PLANNING TECHNICAL REVIEW COMMITTEE –AGENDA

Meeting Type: Regular Meeting
Meeting Location: Council Conference Room, City Hall, 288 Central Ave, Dover NH 03820
Meeting Date: **Thursday, July 20, 2023**
Meeting Time: **10:30 AM**

2. 11:15 AM – 12:00 PM: Open Space Subdivision for Stonearch Development Corp. & Eugene A. and Donna L Sgrignuoli, Assessor's Map E, Lot 65-1 & 65-A, zoned R-20, located between 53 & 65 Tolend Road and 22 Sun Hawk Lane. (Proposal is for a 27 lot subdivision with 2 open space areas) (SUBD-2023-0005).
(This item was previously heard in Technical Review Committee on May 18, 2023)

OVERVIEW SITE PLAN
LAND OF
59 TOLEND RD LLC &
EUGENE A. & DONNA L. SGRIGNUOLI
22 SUN HAWK LANE
TOLEND ROAD
DOVER, NH
TAX MAP E, LOT 65-1 & 65-A

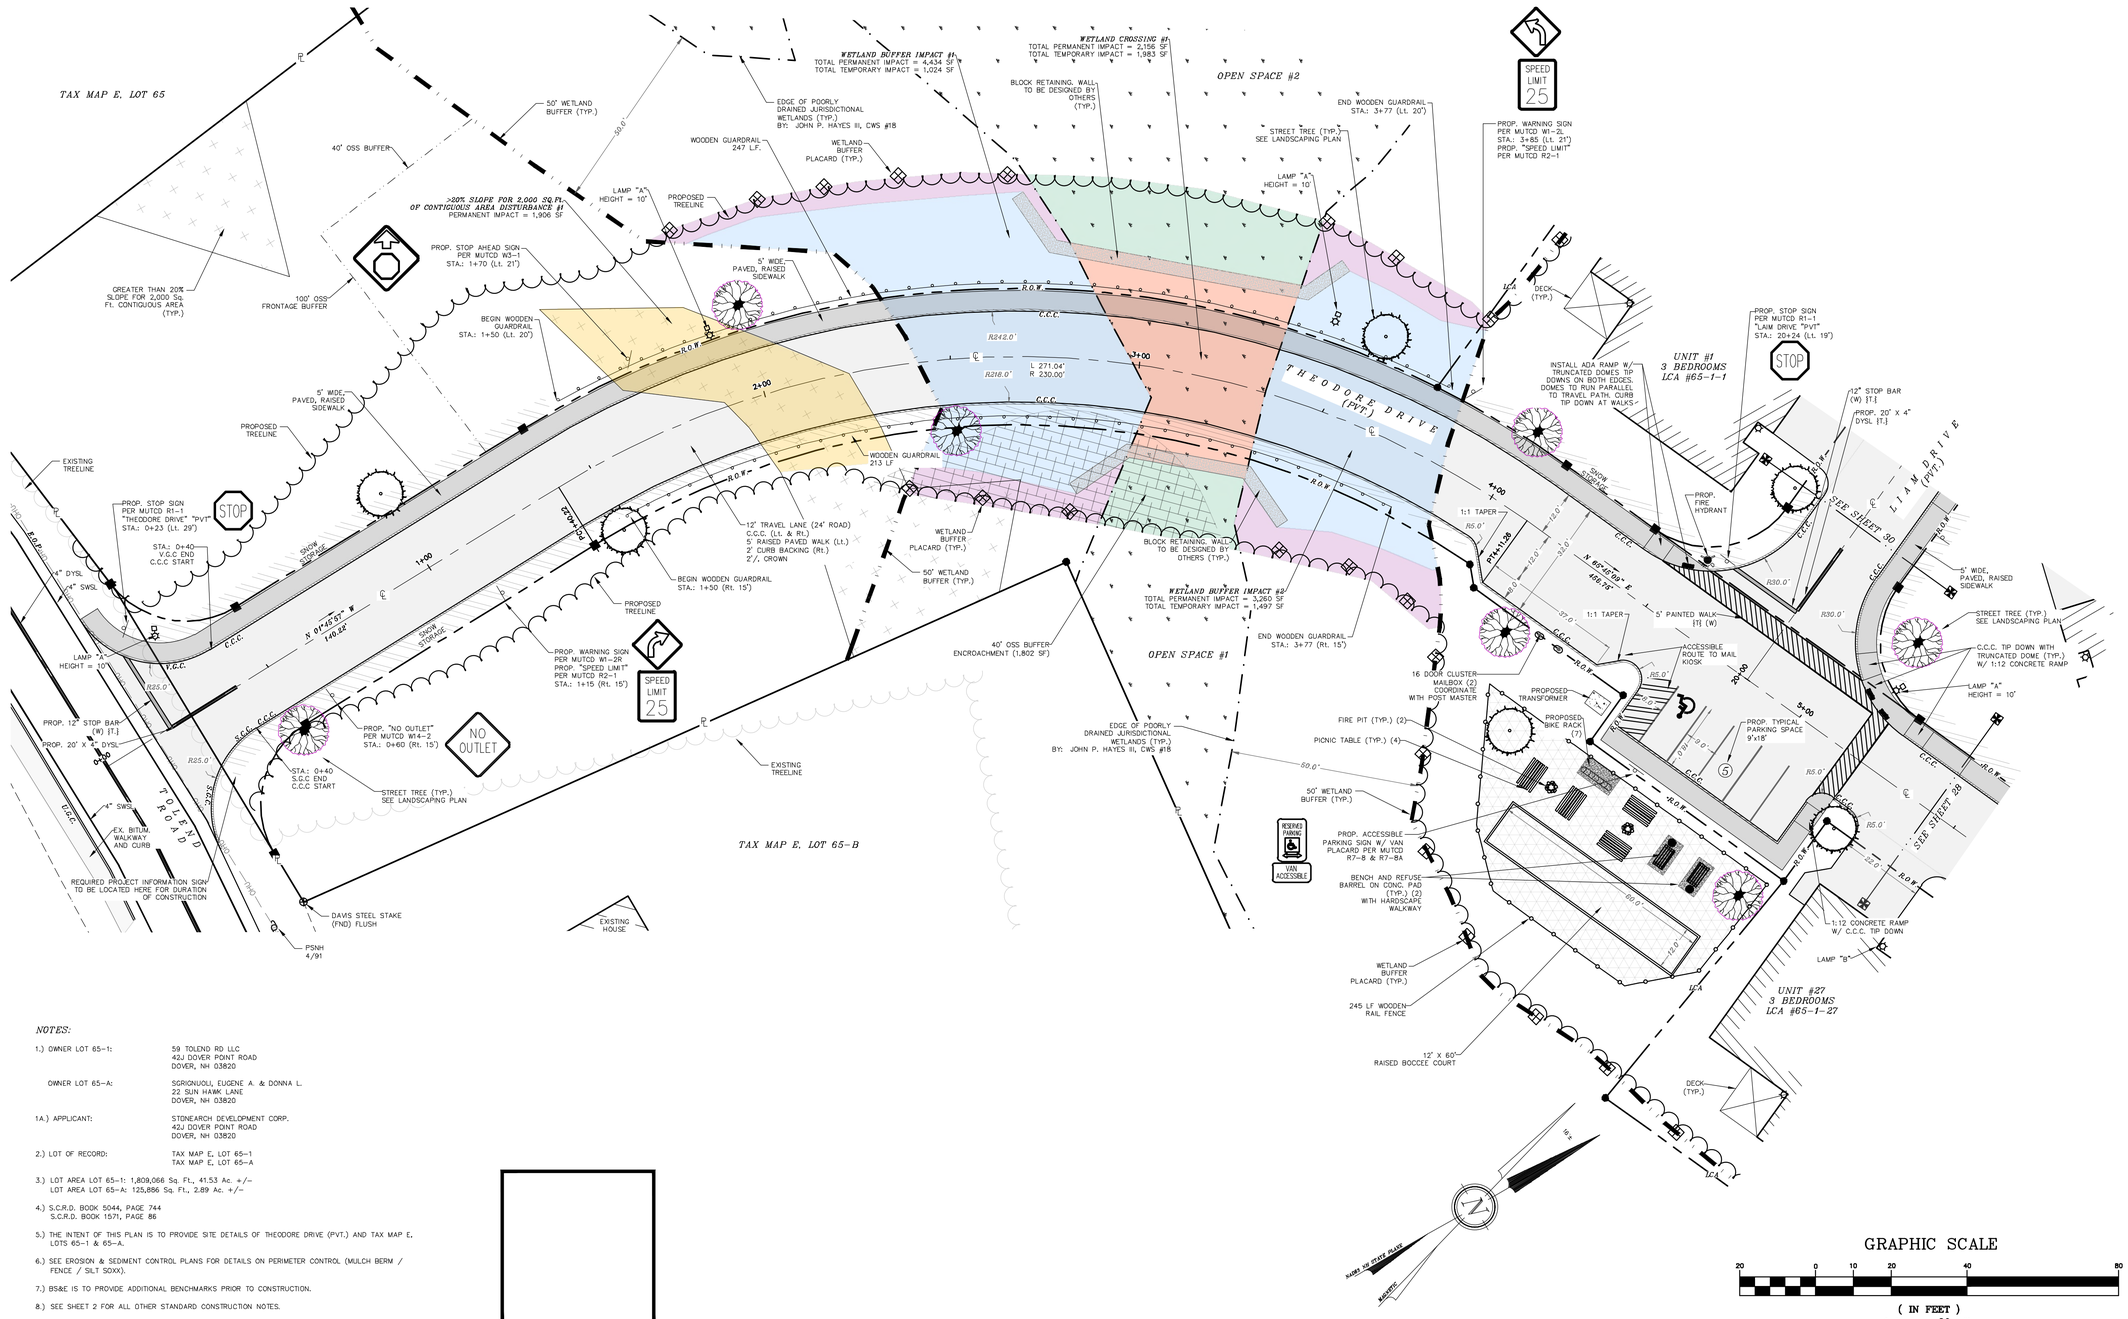
The private road note has been added to the Overview Site Plan, note #10, sheet #26.

j. Provide open space calc note.
Please find Open Space calc note on the Legend Plan & Density Calculations, sheet #3 and on the Overview Site Plan, sheet #26.

PLAN & PROFILE THEODORE DRIVE 0+00 TO 4+00
LAND OF
59 TOLEND RD LLC &
EUGENE A. & DONNA L. SGRIGNUOLI
TOLEND ROAD
DOVER, N.H.
TAX MAP E, LOT 65-1 & 65-A

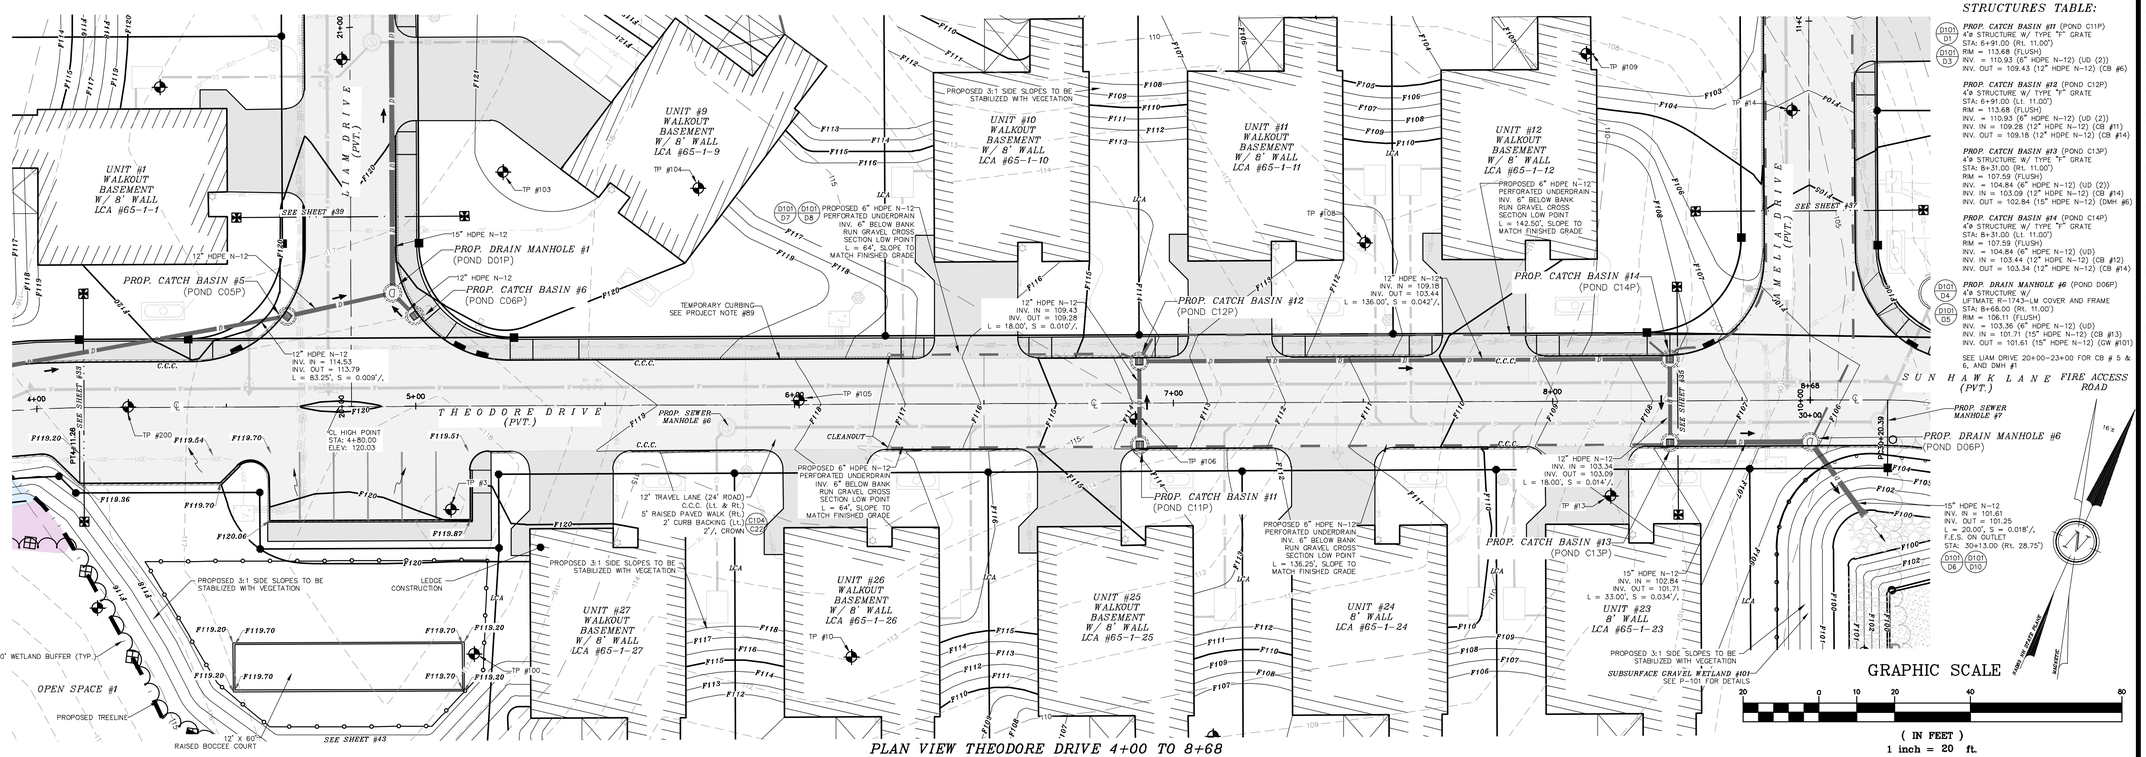
41. Sheet 79: Recommend flattening grade of Theodore Dr. from edge of existing pavement to station 00+50 (or where the proposed driveway meets existing grade).
The Theodore Drive entrance profile has been revised, a waiver is no longer required for this intersection. Please find sheet #54.

LIGHTING PLAN
LAND OF
59 TOLEND RD LLC &
EUGENE A. & DONNA L. SGRIGNUOLI
TOLEND ROAD
DOVER, N.H.
TAX MAP E, LOT 65–1 & 65–A

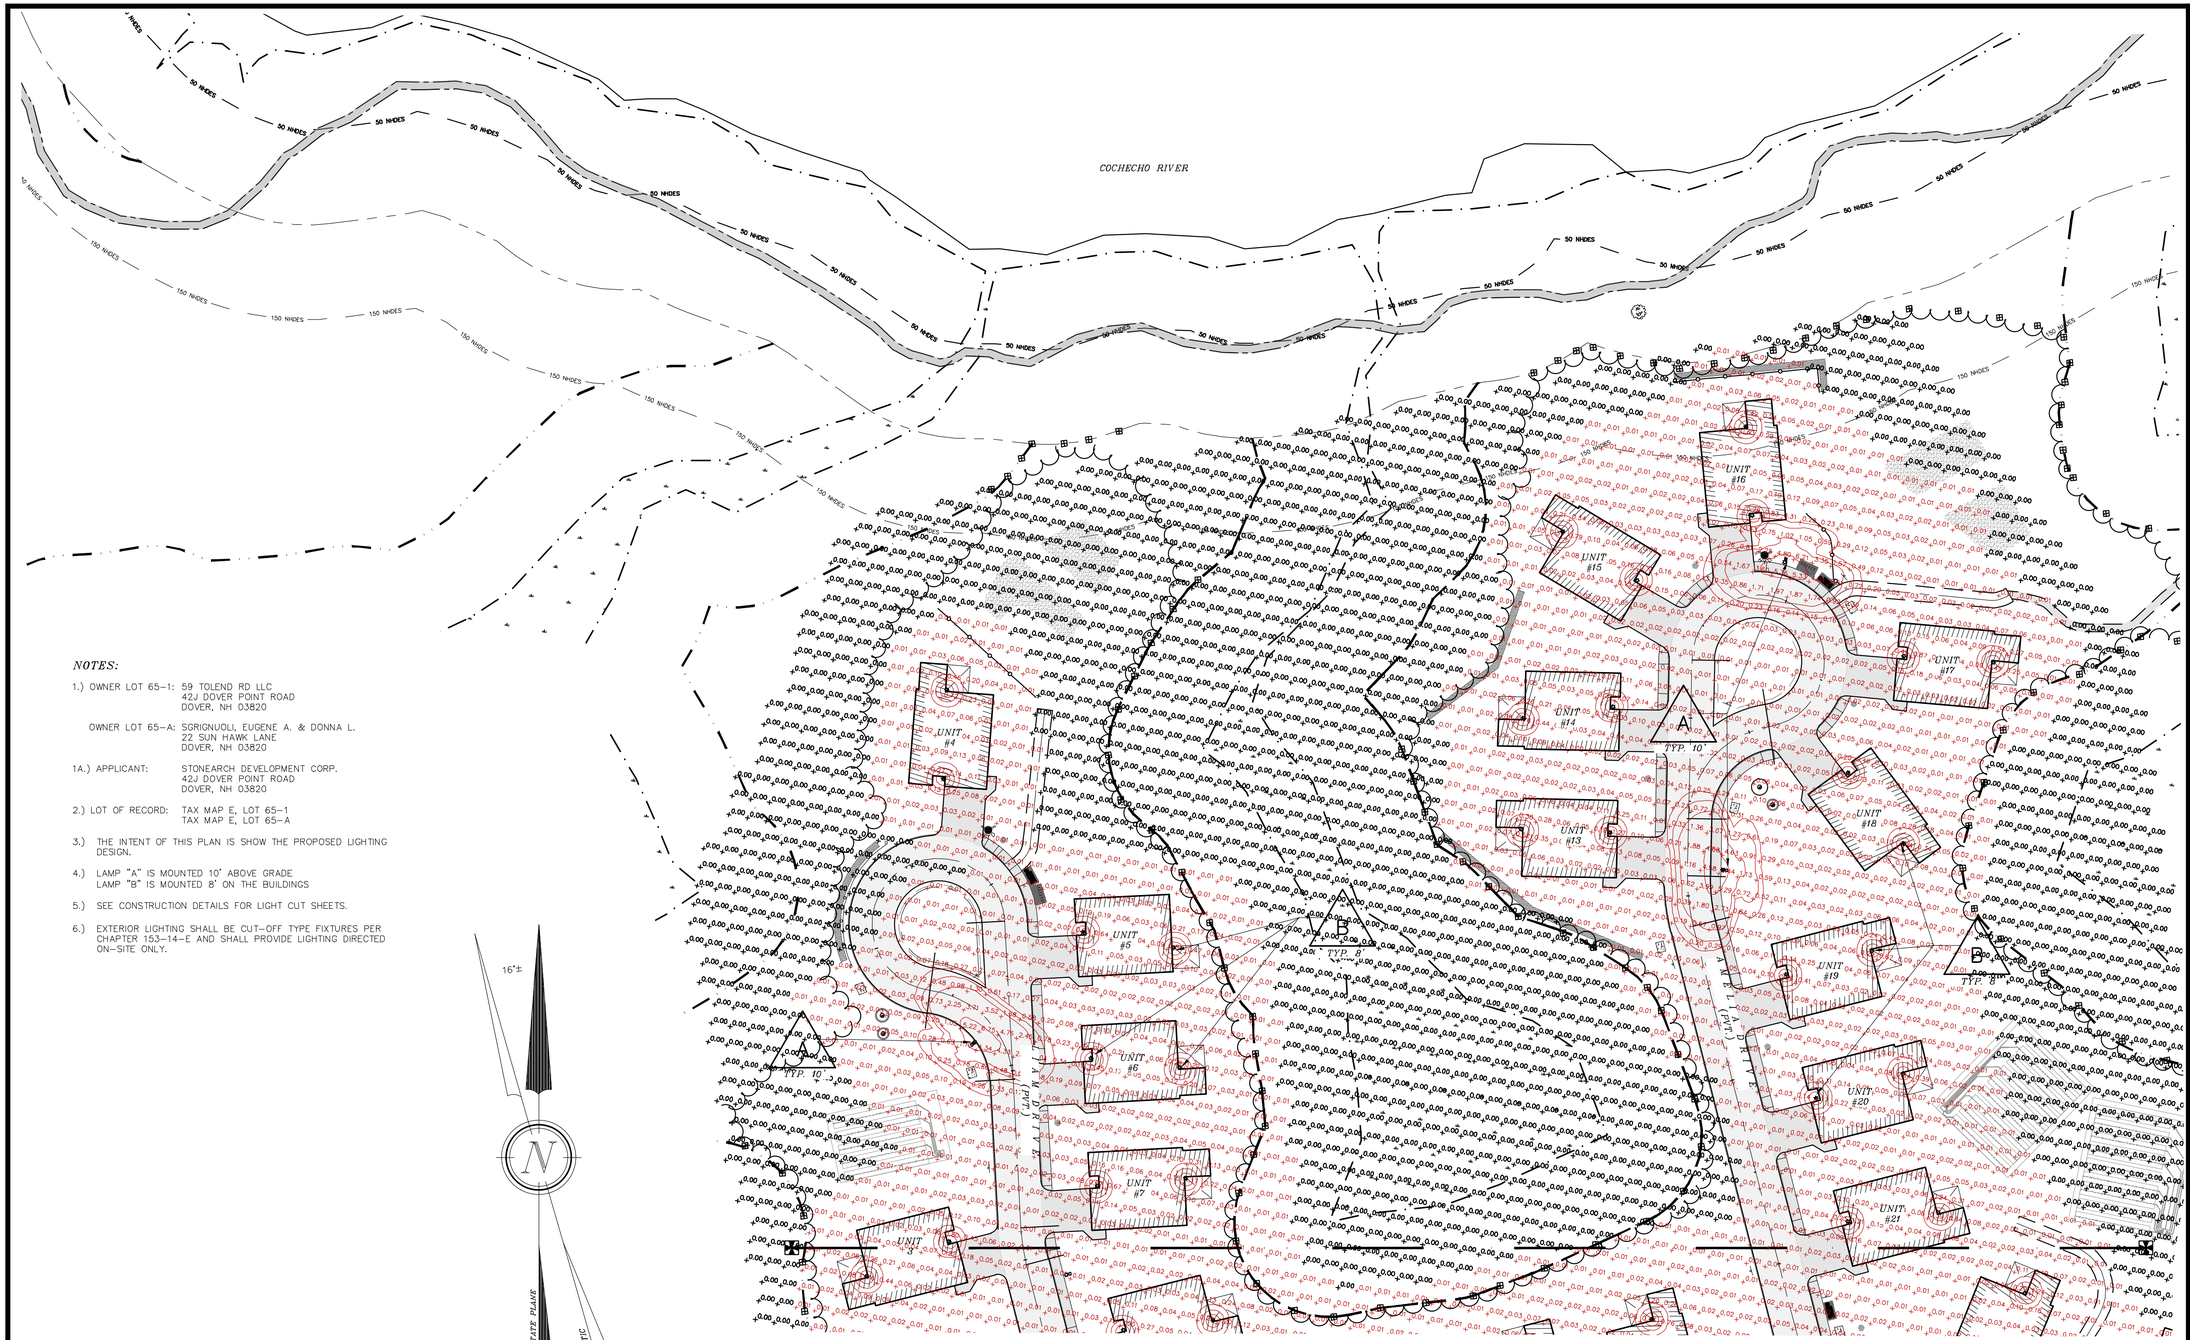
40. Sheet 73: Recommend adding lights along Theodore Dr. to provide continuous light on the main run.
Lighting along Theodore Drive has been revised. Please find Lighting Plan, sheet #73.
